Office Action Summary

10/608,701

VANDEWALLE, MARK V.

DETAILED ACTION

Figure 1

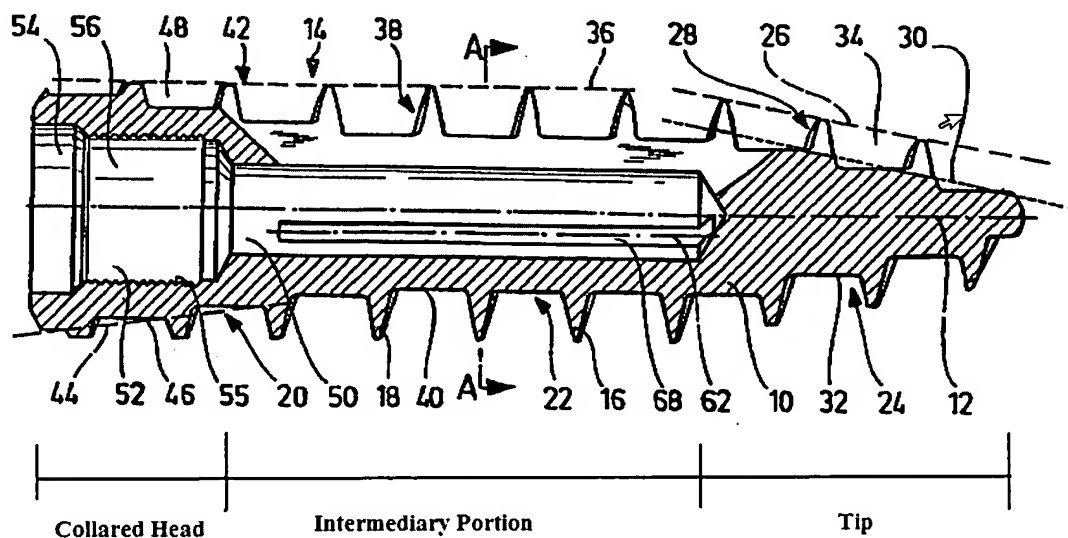
Schultheiss et al. discloses a bone screw anchor (10) that is operable to secure an implant to a bone that has and externally threaded (14) intermediary portion; a pointed self-tapping tip, comprising of a cutting flute that extends across a part of the intermediary portion, located at a first end of said intermediary portion; a collared head, comprising of a cutting flute, located at a second end opposite of said tip that has an interface capable with a driving tool; and a threaded interior (55) bore (50) extending through said head and through said intermediary portion, where it is operable with threads of the fastening device (a screw) to secure the implant to the bone (see Fig. 1 below). Schultheiss et al. also discloses a port (62) on the sides of the anchor that can communicate with the interior bore (50) that is at least partially filled with bone cement, an intermediary portion that is completely threaded that has a larger diameter than the tip and an interface of said head that has at least one recess (54) operable to mate with said driver.

Schultheiss et al. discloses the method steps of securing an implant to a bone which includes implanting a bone screw anchor within the bone using a driving tool operable with the head of the anchor; injecting bone cement into a threaded bore extending through the head to at least a portion of the intermediary portion using a cement delivery device that allows the anchor to be secured; and securing the implant to the anchor using a threaded fastening device secure within the bore. Schultheiss et al. also discloses that the internally threaded portion is inherently protected during the ejecting step, the delivery device is connected to the internal thread of the anchor to protect the threads from being contaminated with bone cement during the injecting step and the bone cement exits at least one port located on the side of the anchor.

Schultheiss discloses the claimed invention except for and open tip or a screw head having grooves. Wolf discloses a groove to receive a driving tool to optimize

Figure 2

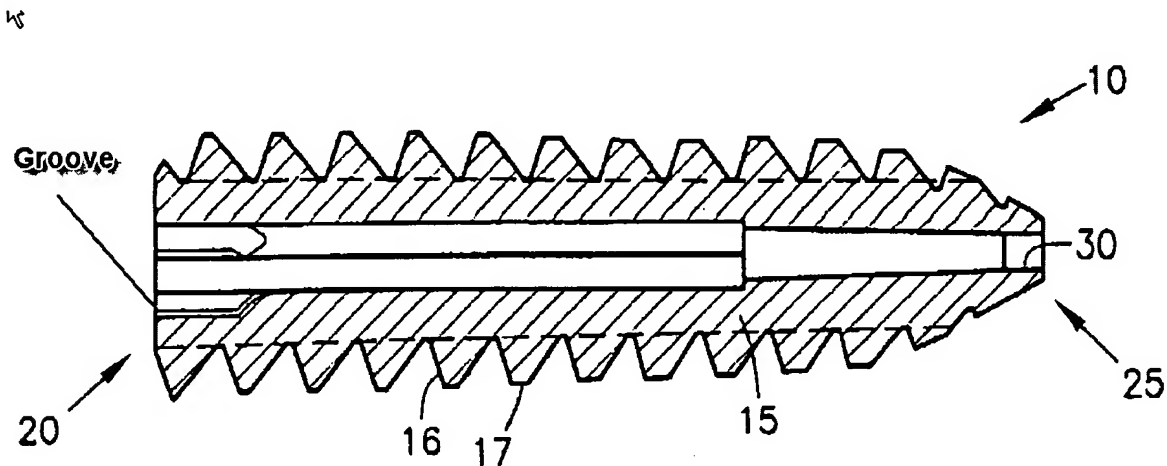
torque capacity when inserting the device. Wolf also discloses an open tip (30) so that a guide pin may be used during delivery and installation. It would have been obvious to one skilled in the art at the time the invention was made to construct the device of Schultheiss with a head defining a groove as well as an open tip in view of wolf, in order to have a device that can be installed with ease and accuracy.
